Responses to EPC June 11, 2019 Comment Letter:

Transportation / Traffic Impact Study (TIS)

Falcon Marketplace (LSC #164350)

Figure 9

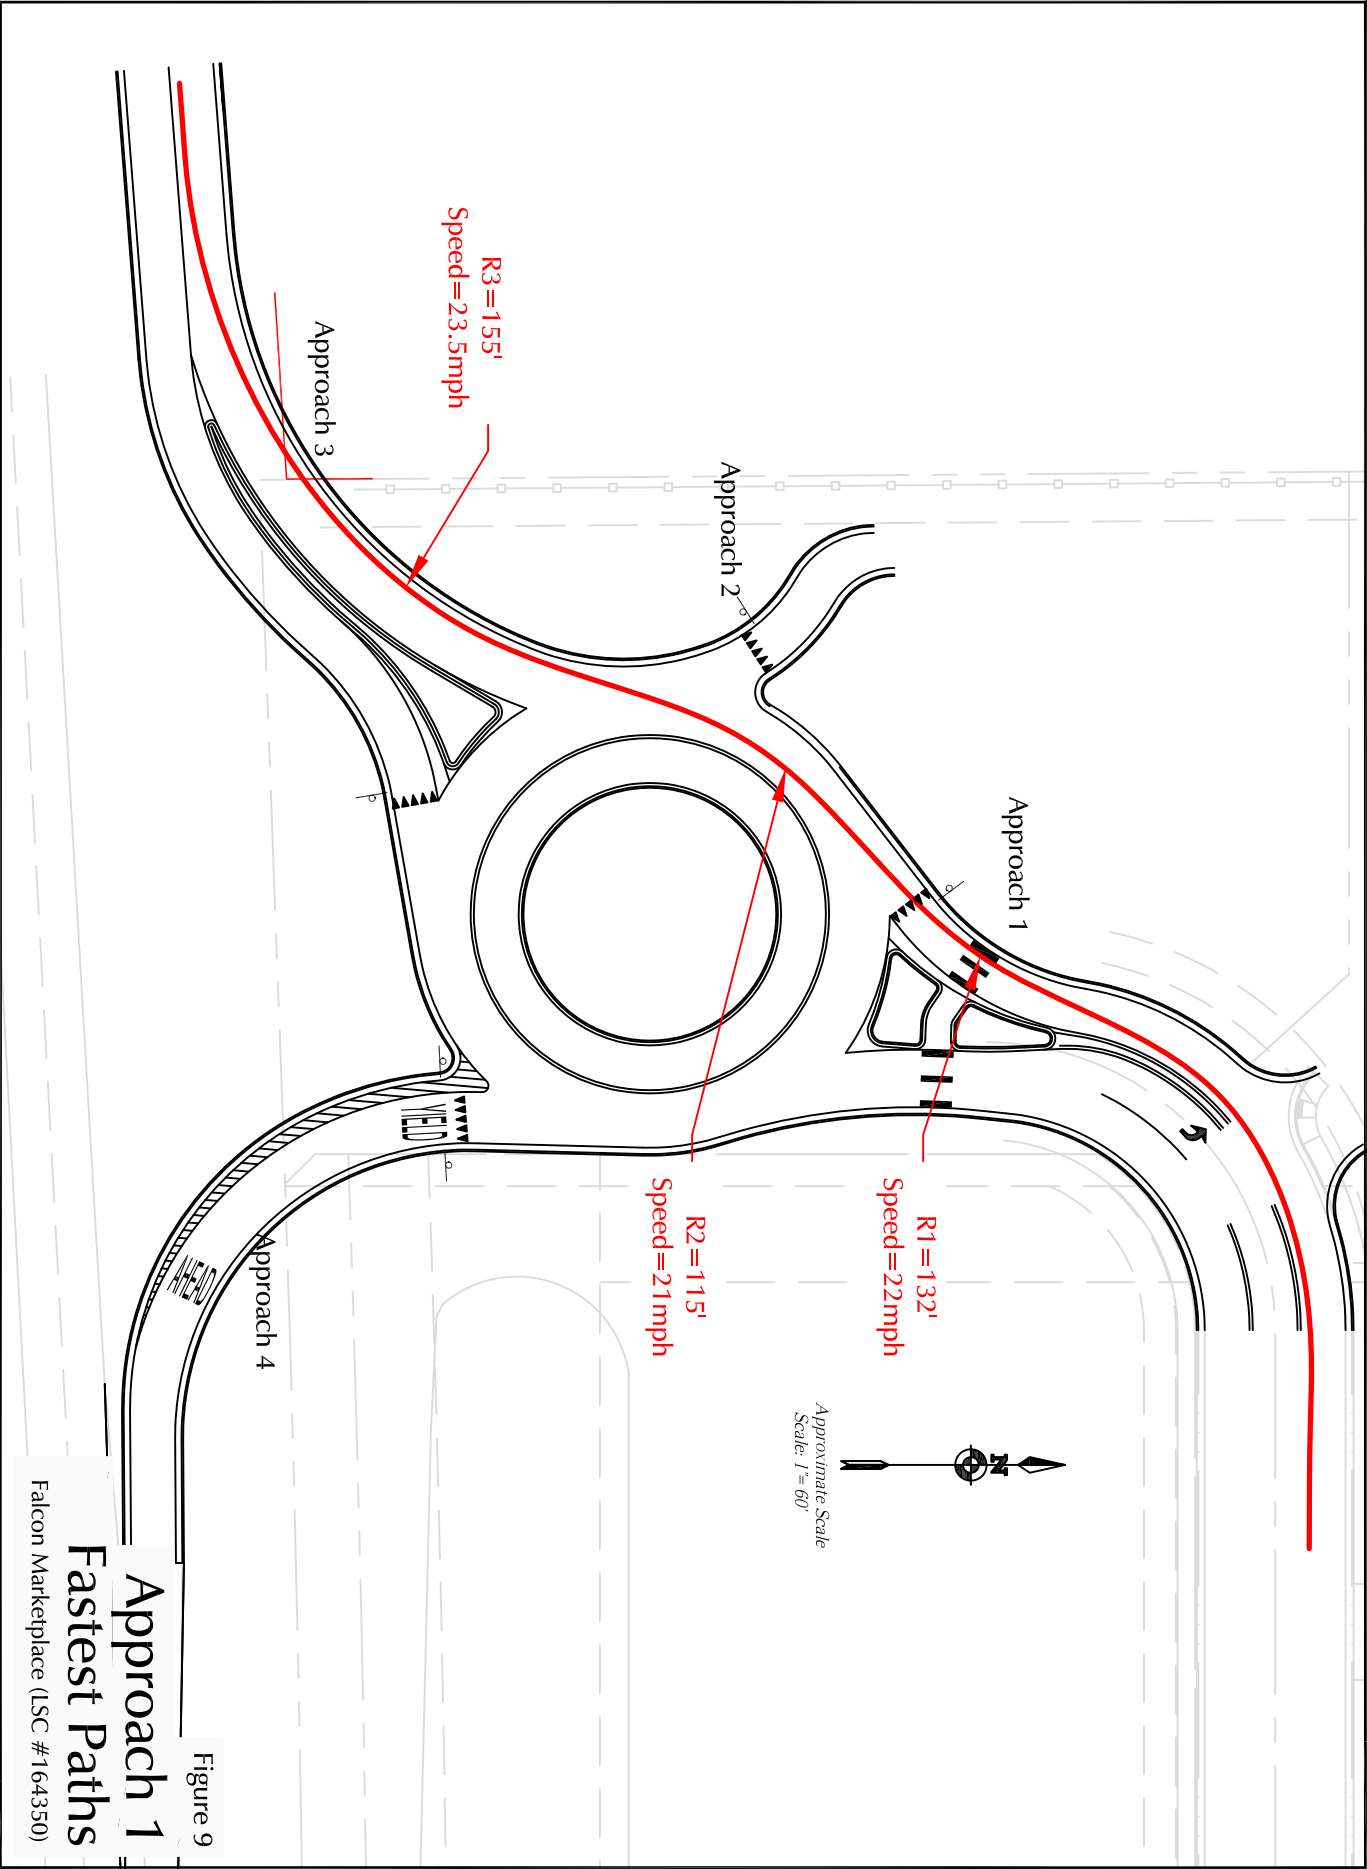
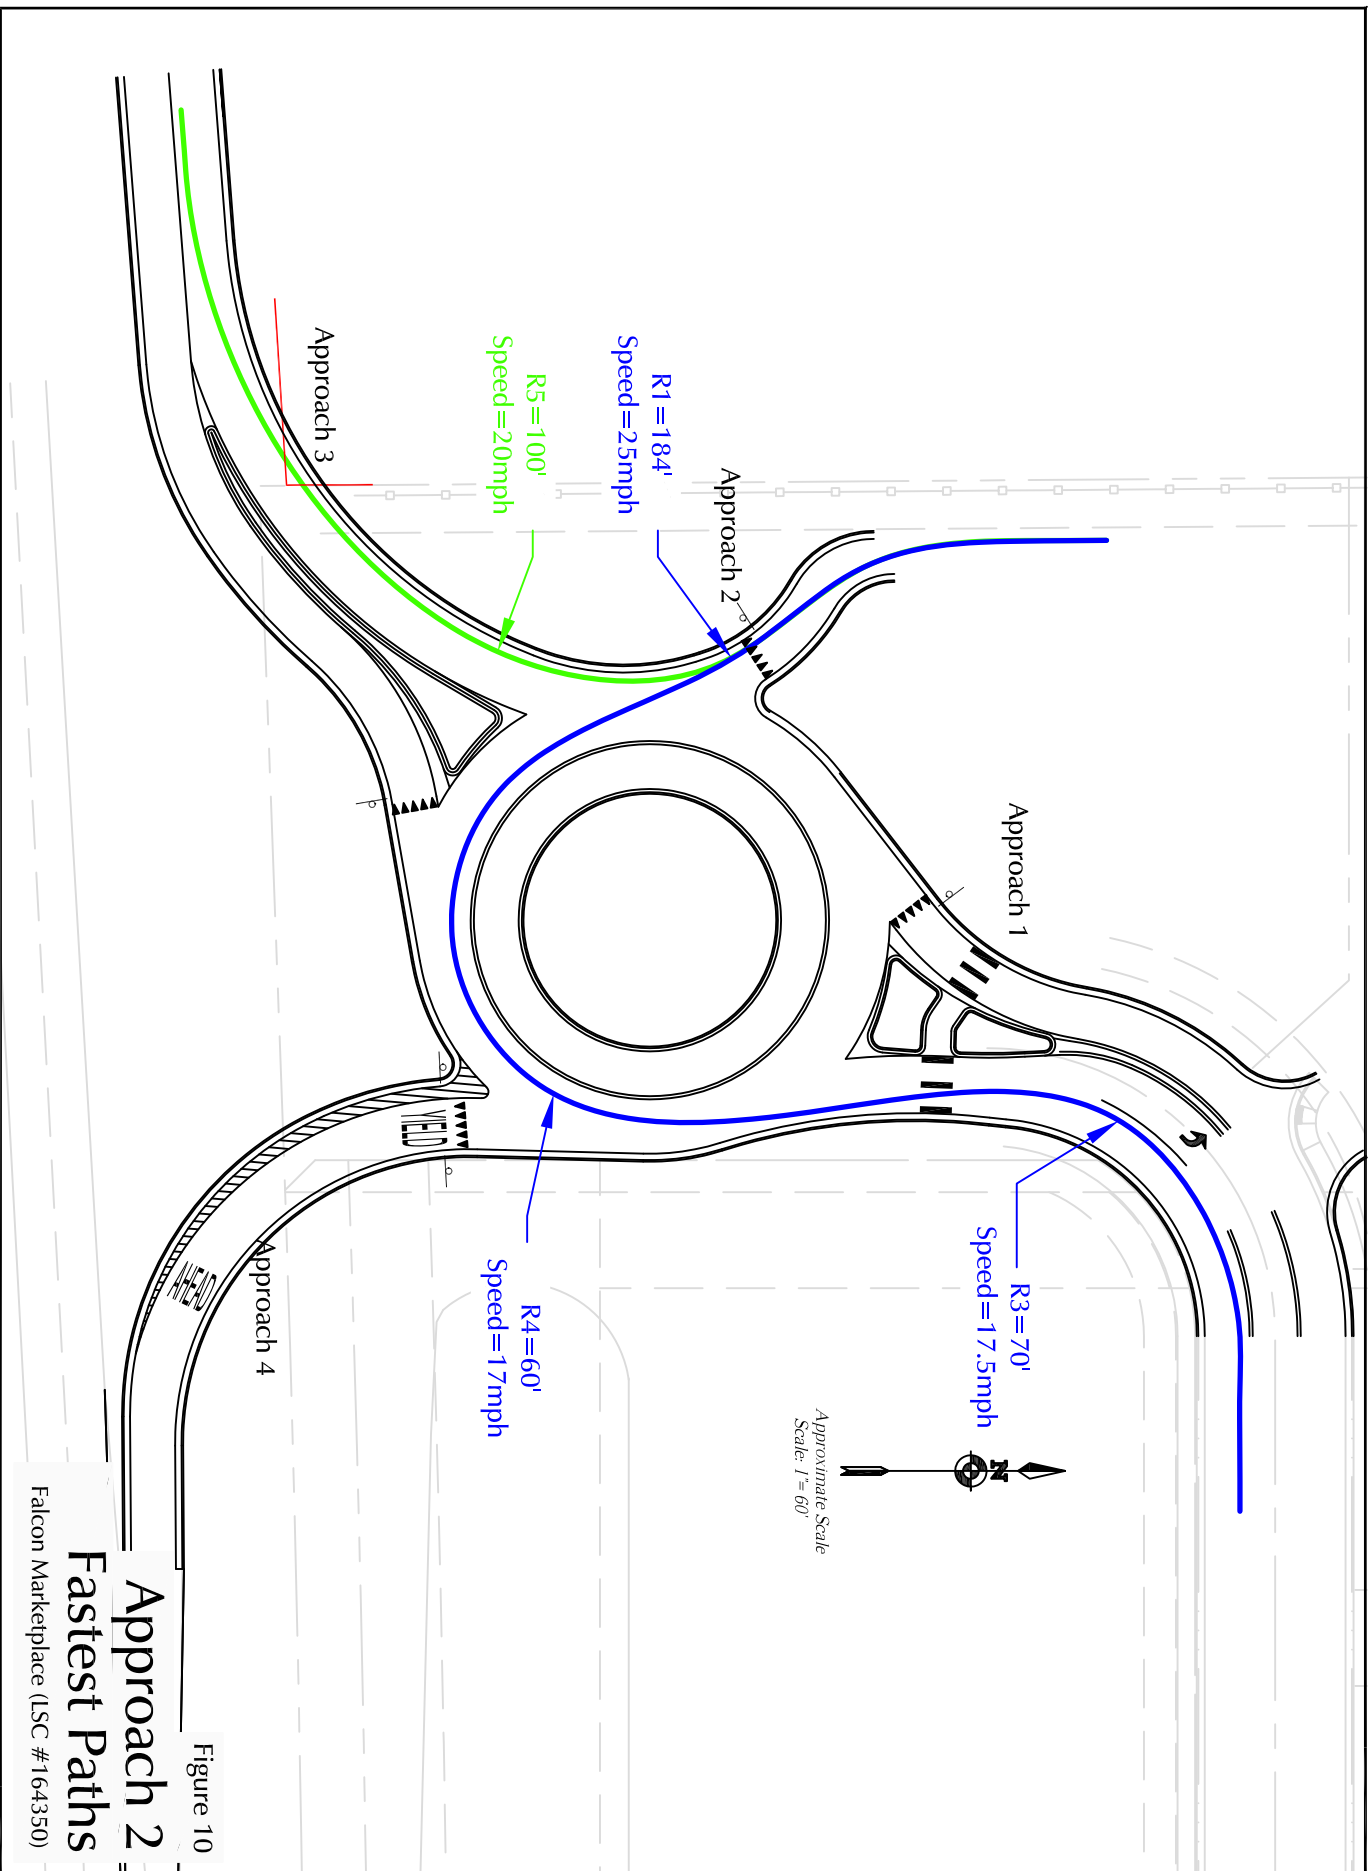
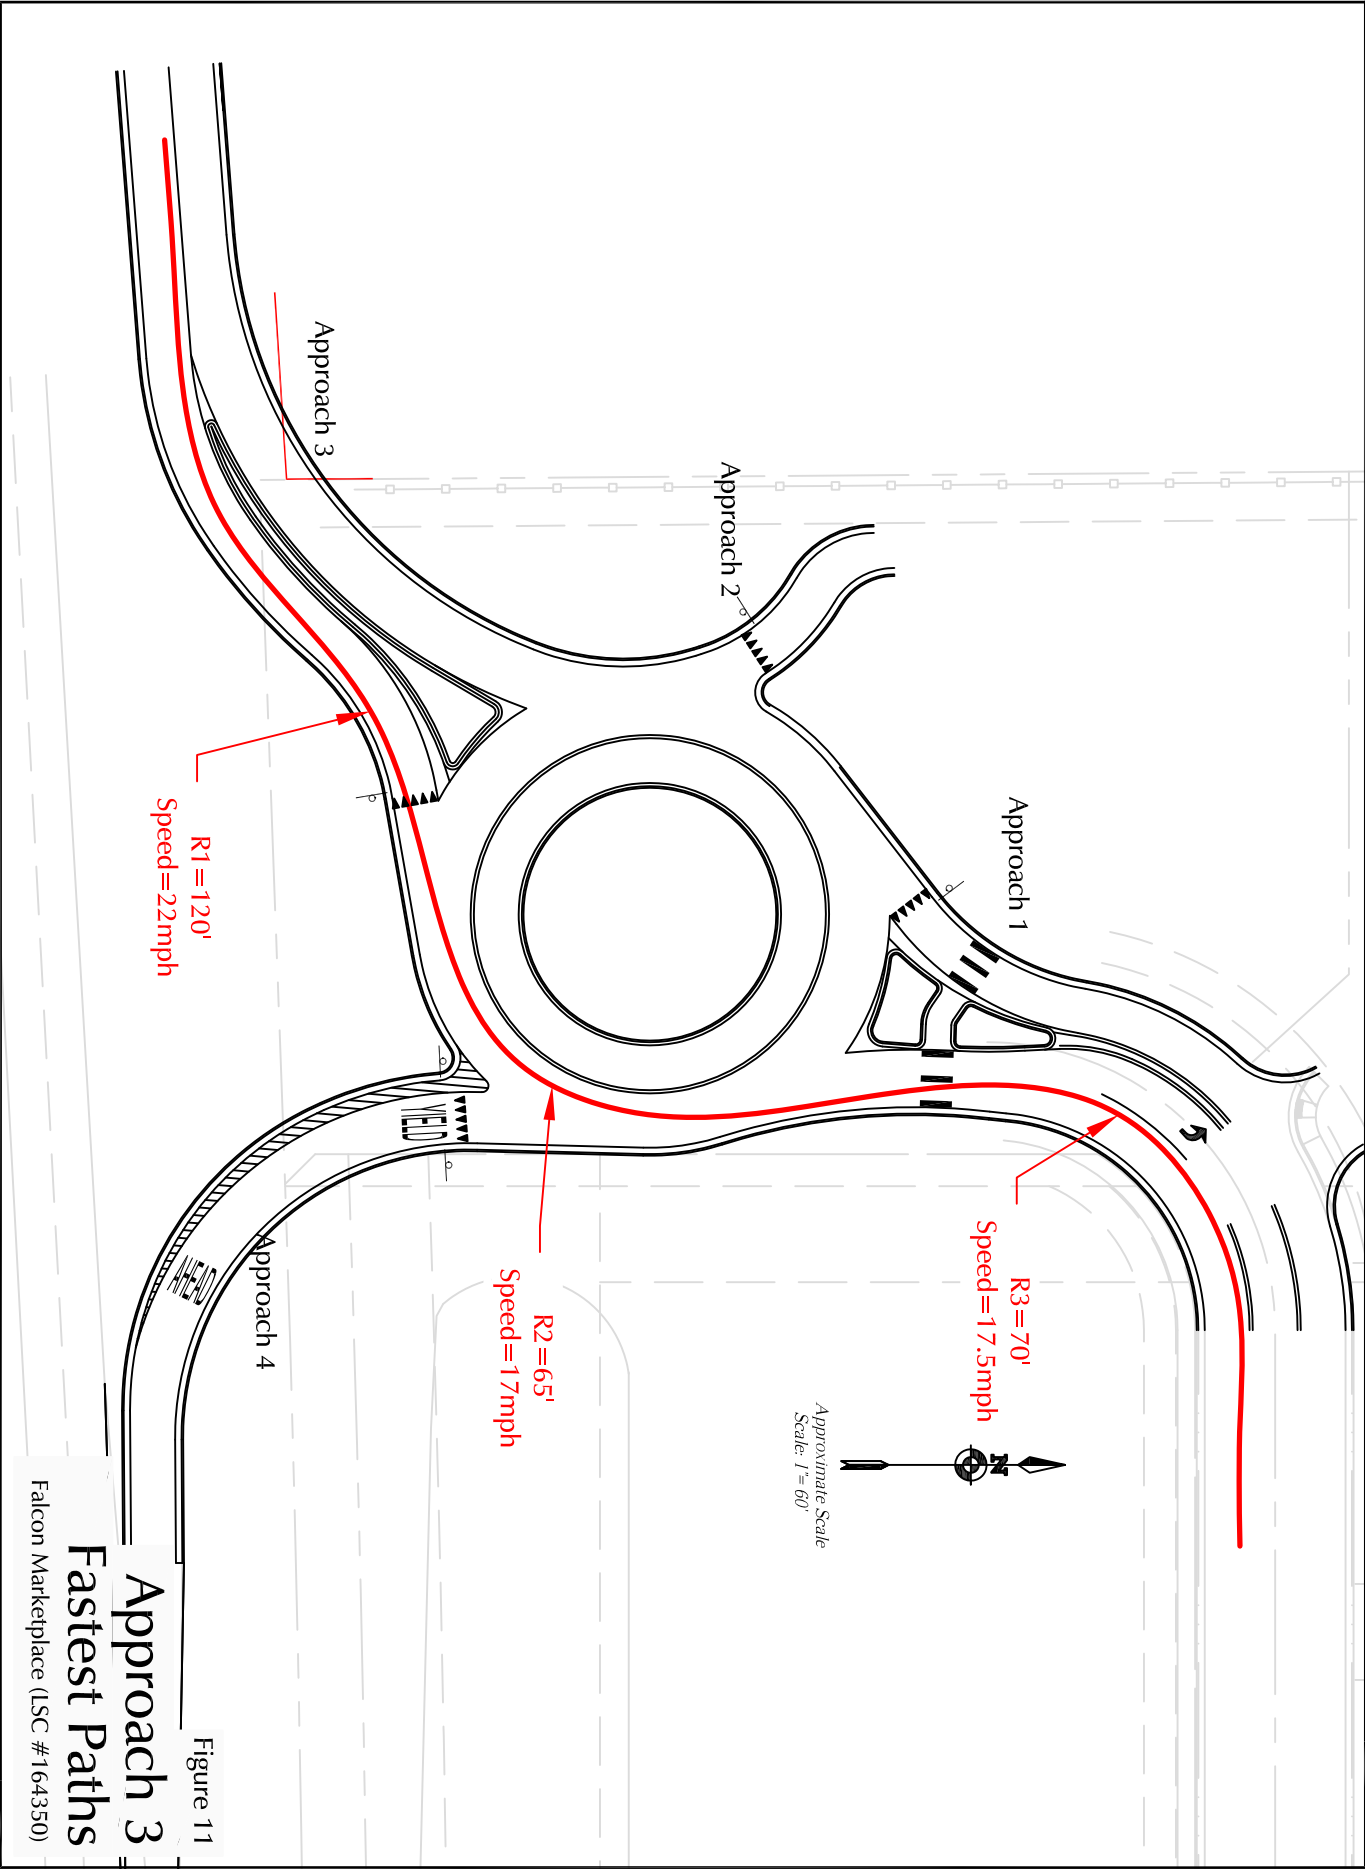
3. *The Phi angle and fastest path combinations are 16 degrees and 22mph for the SW approach, 37 degrees and 25mph for the SE approach (from a parking lot), 17 degrees and 22mph for the NE approach and 16 degrees and 20mph for the NW approach. The recommended fastest path is 25mph and all three approaches with a Phi of less than 20 degrees have fastest paths of between 20mph and 22mph so meet the intent of the Wisconsin DOT guidance provided above.*
